NAVAL BIODYNAMICS LABORATORY  
NBDL-91R003

## HUMAN FACTORS ASSESSMENT OF USCG 47-FT MOTOR LIFEBOAT

Technical Report

## **I: Preliminary Evaluation of Ergonomic and Safety Deficiencies**

Figure I.2. Appropriate and inappropriate ways of descending a ladder.

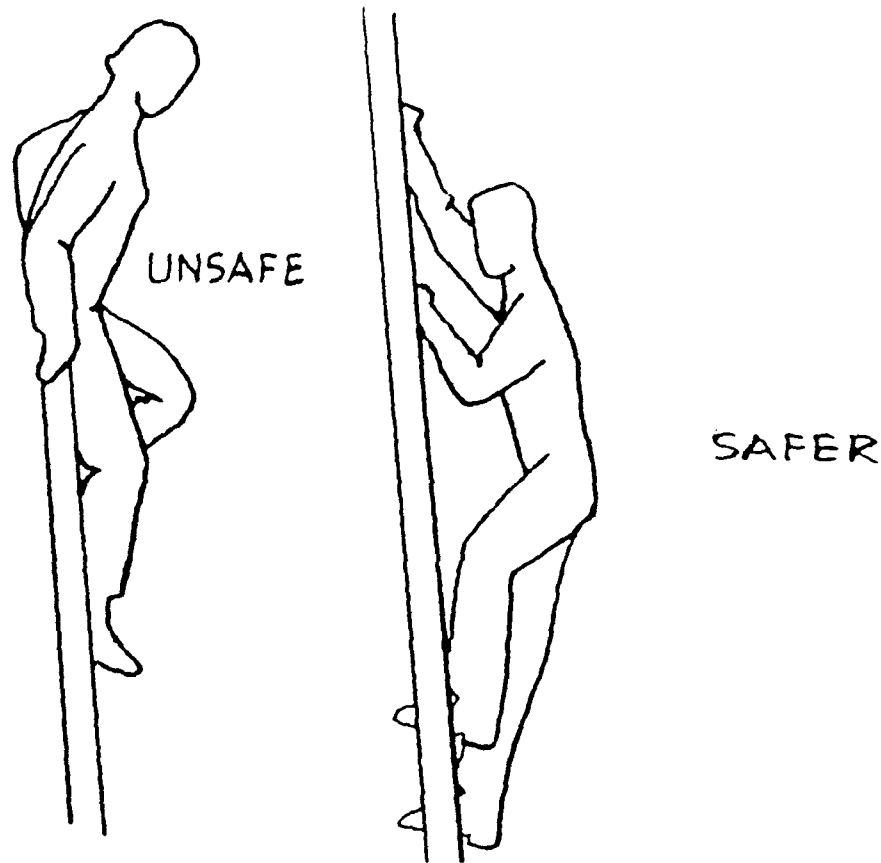
**Caution:** Crewmembers should be discouraged from facing away from the ladder while descending (see Figure I.2). A potential for injury exists, both by falling from the ladder and by falling into the towing bit located on this aft deck.

- In addition the aft ladder does not have a safety restraint or line across its top. This is potentially dangerous for personnel, especially during rough seas.

- An easily movable gate with double bars placed level with the current safety railing would be preferred. Ideally, the gate would be constructed of the same material as the railing and hinged to swing in the desired directions and could be secured in both open and closed positions.
- As an alternative a safety bar may be provided across the ladder access way to prevent crewmembers from falling to the deck below.
- Additional handholds should be provided as braces for the crew. These should be attached along the side and underneath the mast platform. This overhead handhold will allow crew to steady themselves at two points: railing and overhead.

Figure I.3. Watertight door with control wheel, extended handle, and dogs.

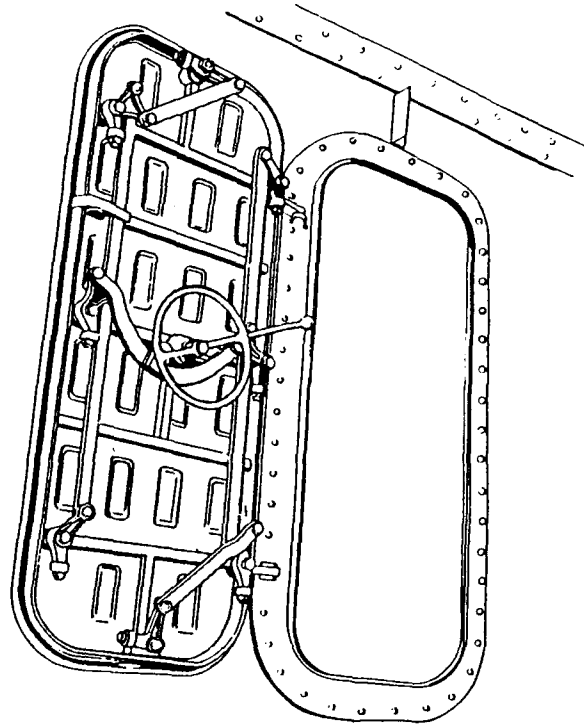
- Problem:**
- Potential for personal injury exists while crew pass through the door. Crew are required to hold the door with one hand, grab the handrail with the other, and walk up the ladder simultaneously. In rough seas crew will not be able to maintain positive control, thereby increasing the risk of injury.

- The door impedes the movement of the port OB chair.
  - The bolts of the door are exposed and present a hazard to the crew passing through the door. Crewmembers have reported minor injuries due to these bolts.

- Approach:**
- The door should be designed with a self-locking mechanism to secure the door in an open position. This mechanism is recommended for all doors.

- All dogs are operated at once by the extended handle located on the control wheel of the watertight door. The handle will provide positive control for the crew (see Figure I.3).

**Figure II.1a.** Current starboard steering station on open bridge.

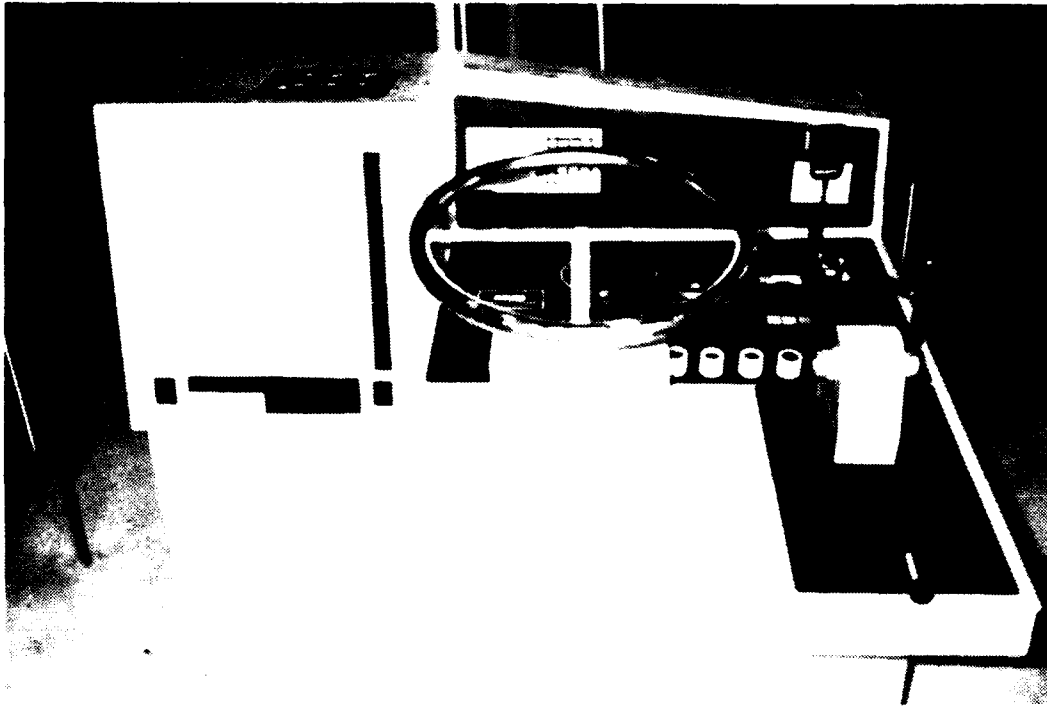
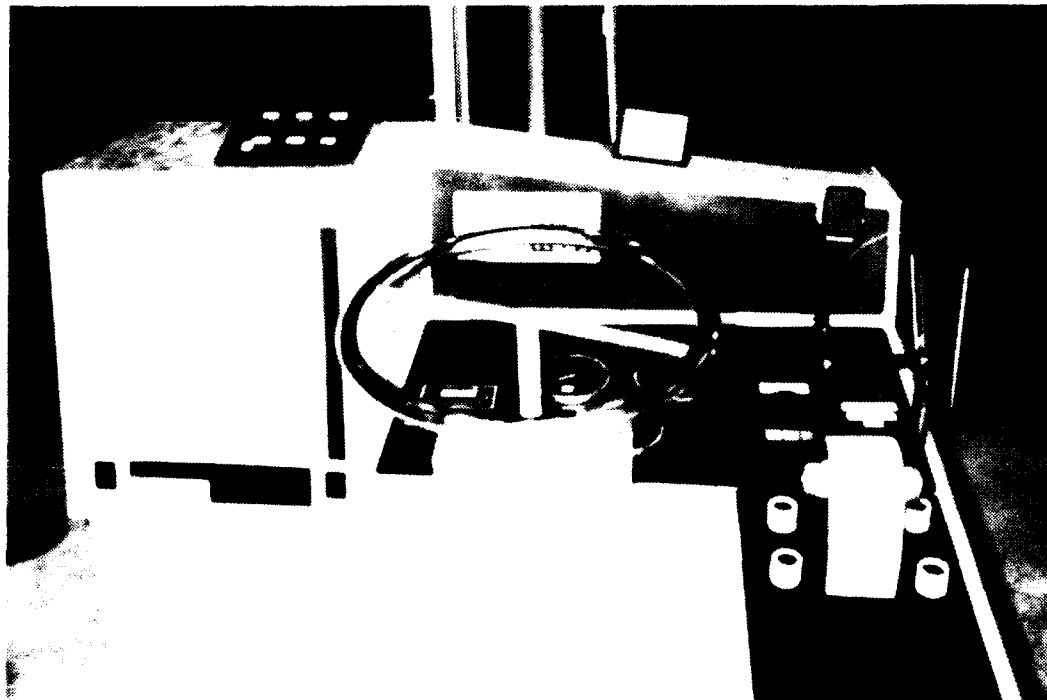
Figure II.1a represents the current layout of the starboard console on the open bridge. The layout of the starboard console (primary steering station) provides both a steering wheel and a backup jog lever steering control.

- In place of two microphones, use a single microphone and selector switch to reduce the viewing obstruction to the control and displays. The switch should be located in close proximity to the microphone (see Figure II.1b).

Figure II.5. Proposed port steering station on open bridge.

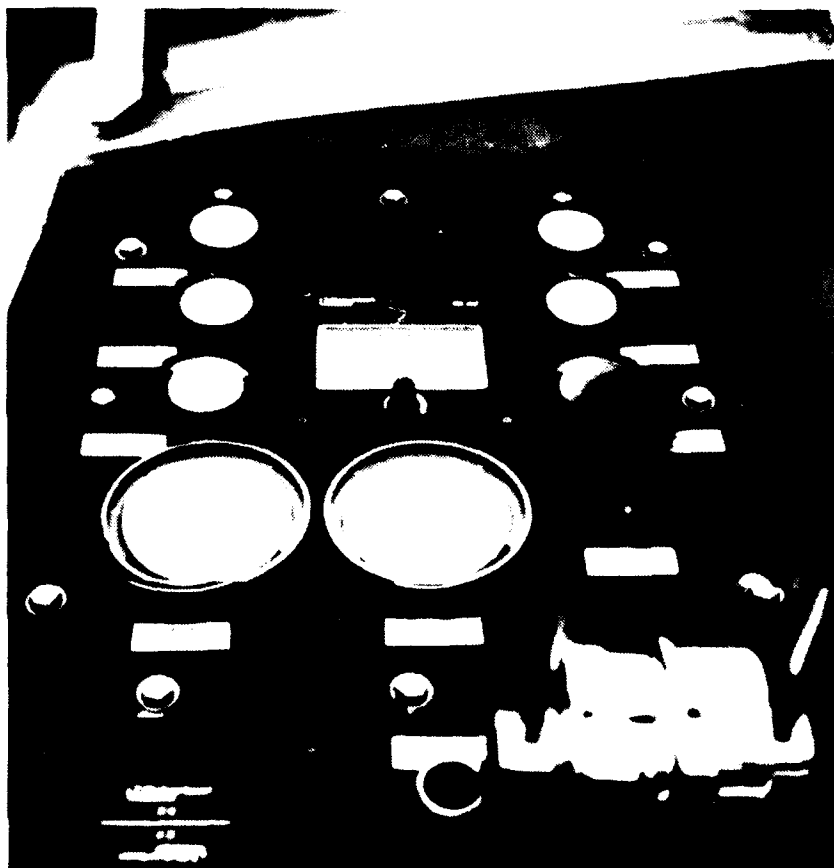
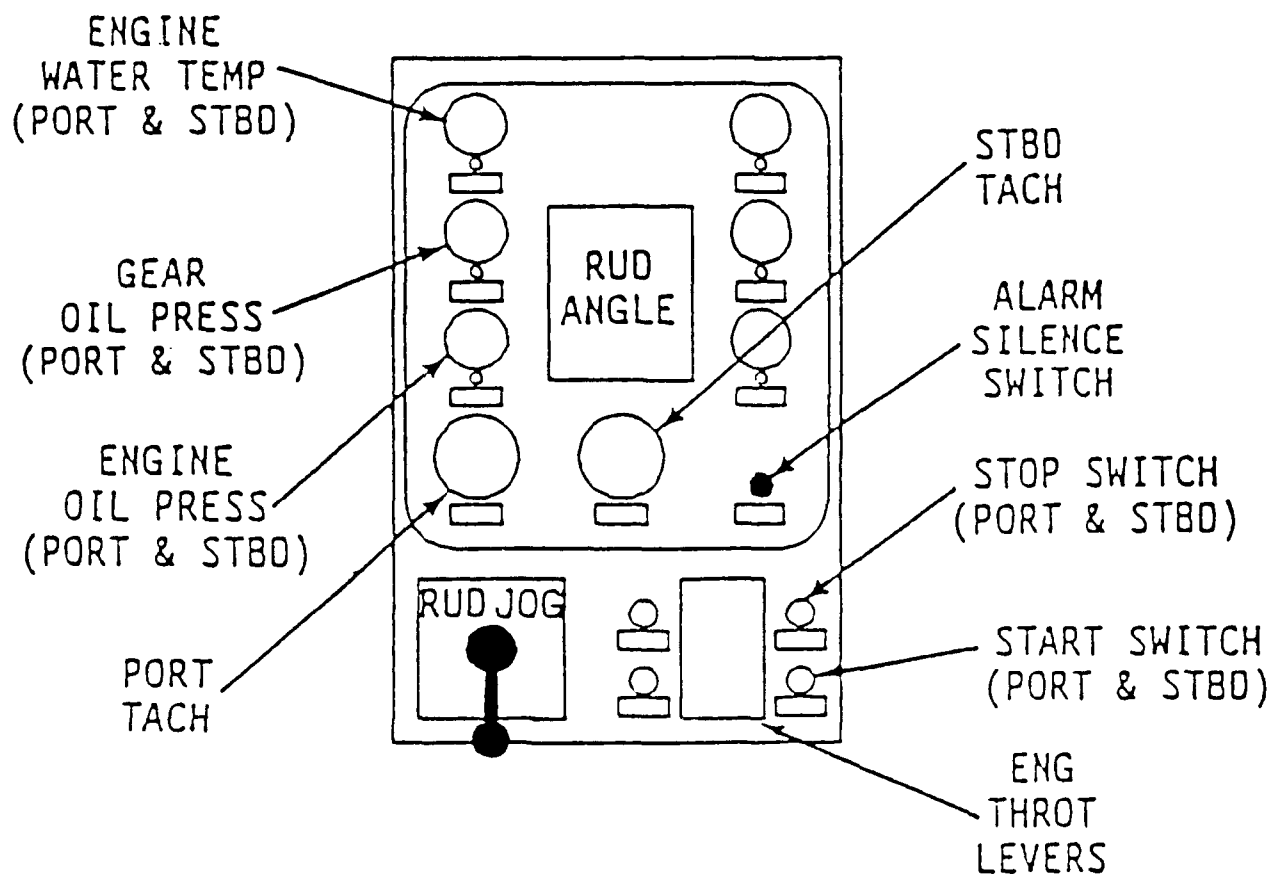
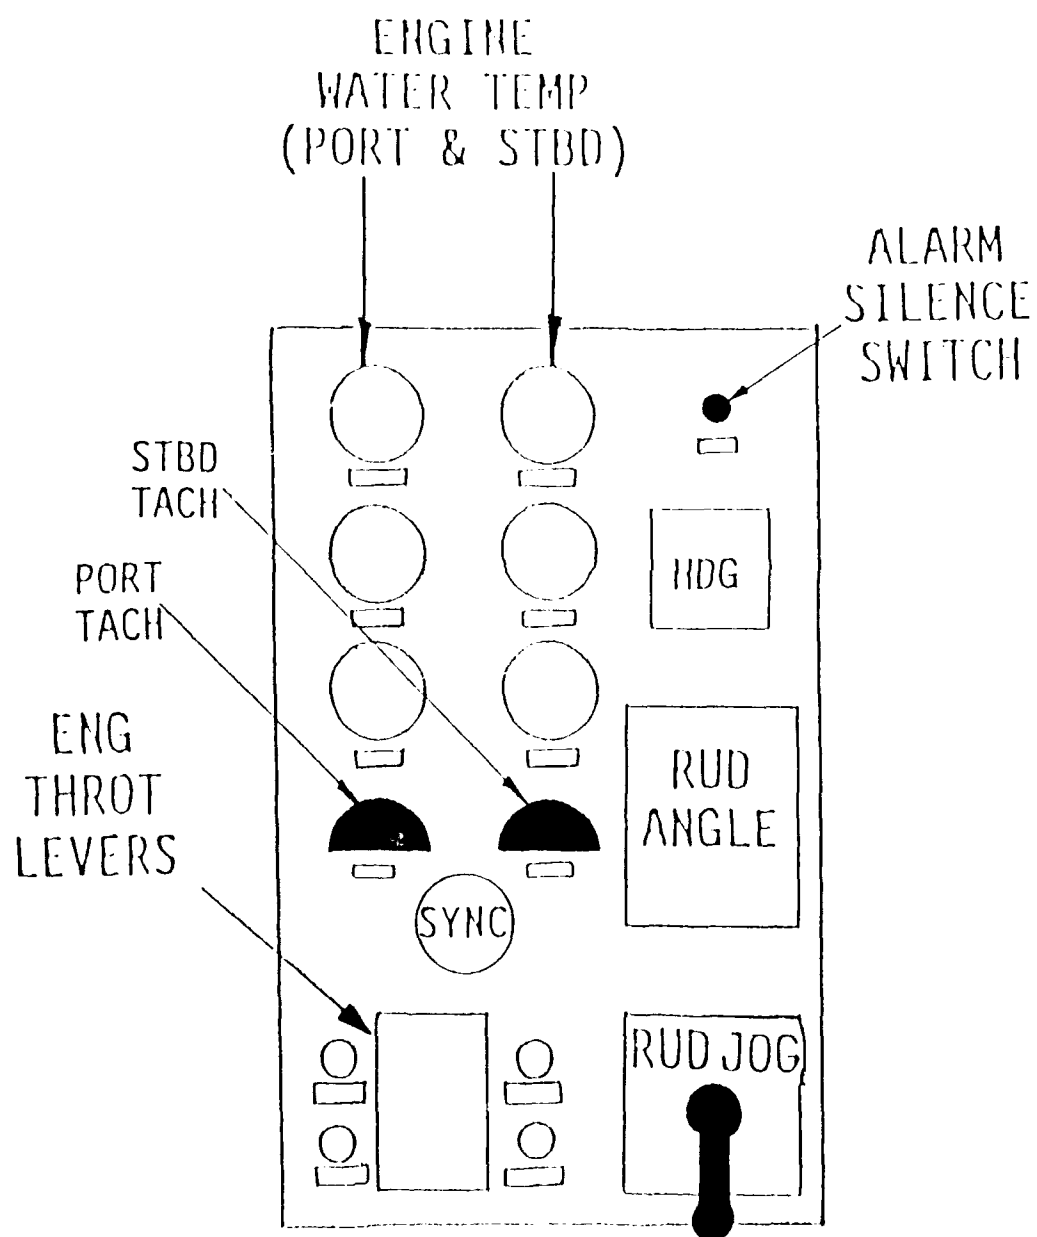
- The proposed console layout is recommended to avoid scattering controls and displays on the console without regard to functional associations (see Figure II.5).

**Figure II.6.** Proposed autopilot cutoff switch on open bridge.

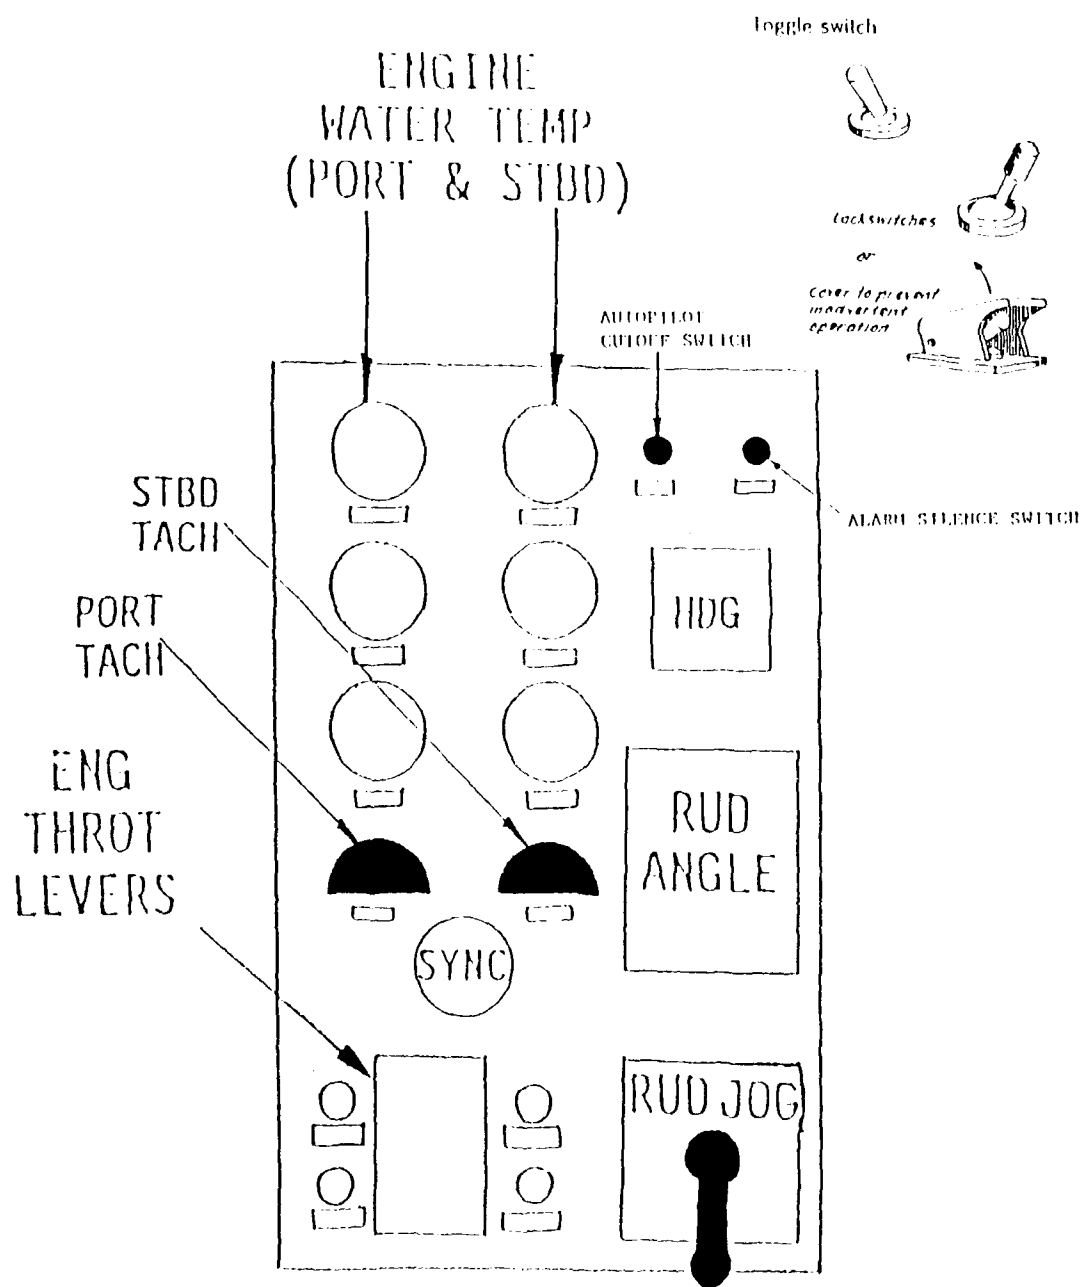
- Place an autopilot cutoff switch above the heading indicator on the port steering station console. A standard two-position toggle switch with a locking mechanism or protective cover to prevent inadvertent activation is recommended (see Figure II.6). The same type of mechanism is recommended for the alarm silence switch. The recommended minimum distance between the two toggle switches
